**AERONAUTICAL CHARTING FORUM**  
**Instrument Procedures Group**  
**October 23, 2012**

**FAA Control # 12-02-304**

**Subject:** FMS Coding of SIDs Containing Multiple or Differing Runway Transitions

# TAMPA FIVE DEPARTURE

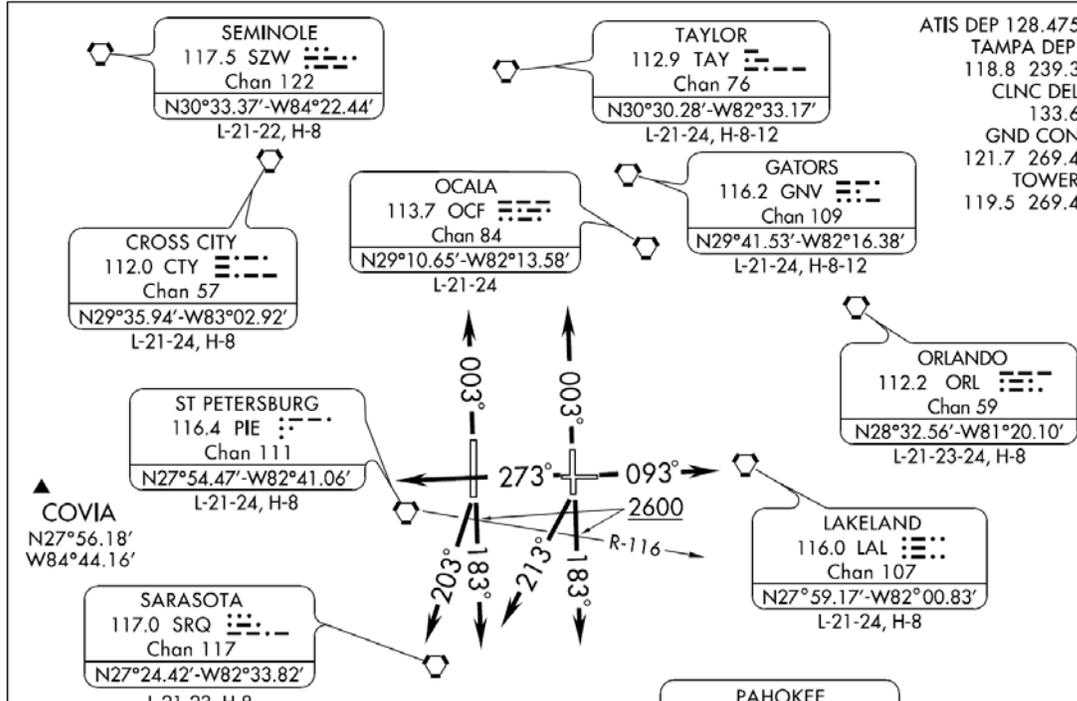
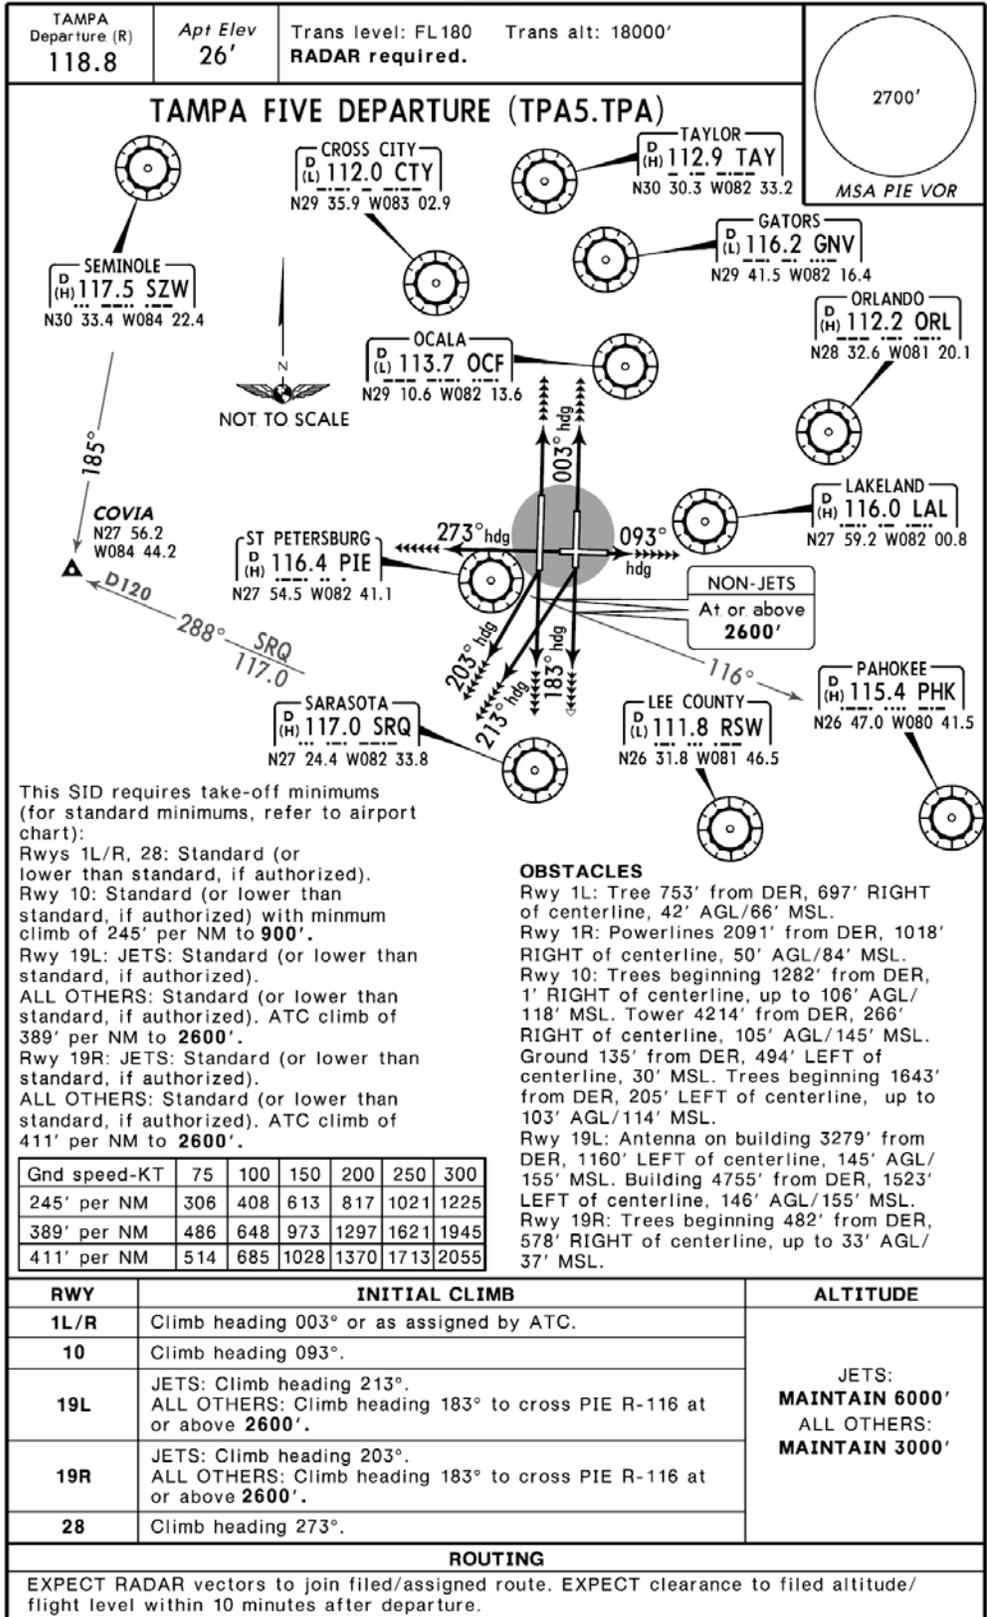
The design of the TAMPA 5 SID (TPA5.TPA) involves two different runway transitions for parallel runways 19L and 19R; one set for "Jets" and another set for "All Other" aircraft. Existing capabilities of the navigation database coding and corresponding electronic displays can accommodate only one runway transition per runway per departure - for either "Jets" or "All Others" - but not for both.

The latter scenario happened recently in Tampa, FL when a pilot was cleared for the TAMPA 5 SID. The pilot, flying a Turboprop airplane, took off from Runway 19L but incorrectly flew the procedure in his installed database. The path he flew was the path for Jet aircraft. The airplane subsequently crossed the extended centerline of parallel Runway 19R. This drew the attention of an alert airline crew and departure control.

3. *Jeppesen, for Cycle 1211, agreed to remove the 19L and 19R runway transitions of the TAMPA 5 departure since the “Jet Only” status of the coded data cannot be communicated at the point of use.*

(7) Do not establish DPs containing more than one initial departure route from the end of a runway to support different types of aircraft (jet, turbo-prop, etc.) or different equipment requirements (DME, non DME). Where this is necessary, separate procedures must be developed.
